ADDENDUM #2

Project: Greenwood Police Department and Municipal Court Renovation
Greenwood, Mississippi

Professional: Beard + Riser Architects PLLC

Date Issued: May 10, 2016

1
E4.1

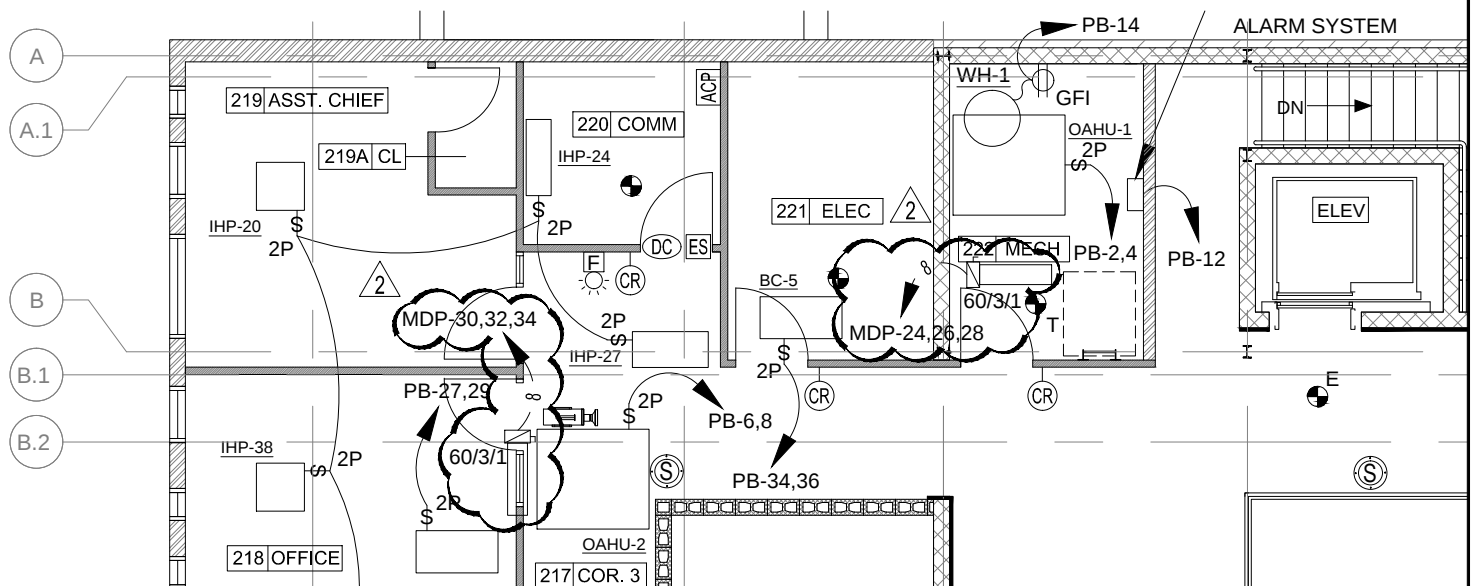
3. **Item 3:** Electrical Revision – Add revised attached Drawing E4.1(1 page).
4. **Item 4:** Drawing Sheet Revisions: Replace the existing drawing sheets with the revised attached drawing sheets – A1.4 & A3.1 (2 pages).
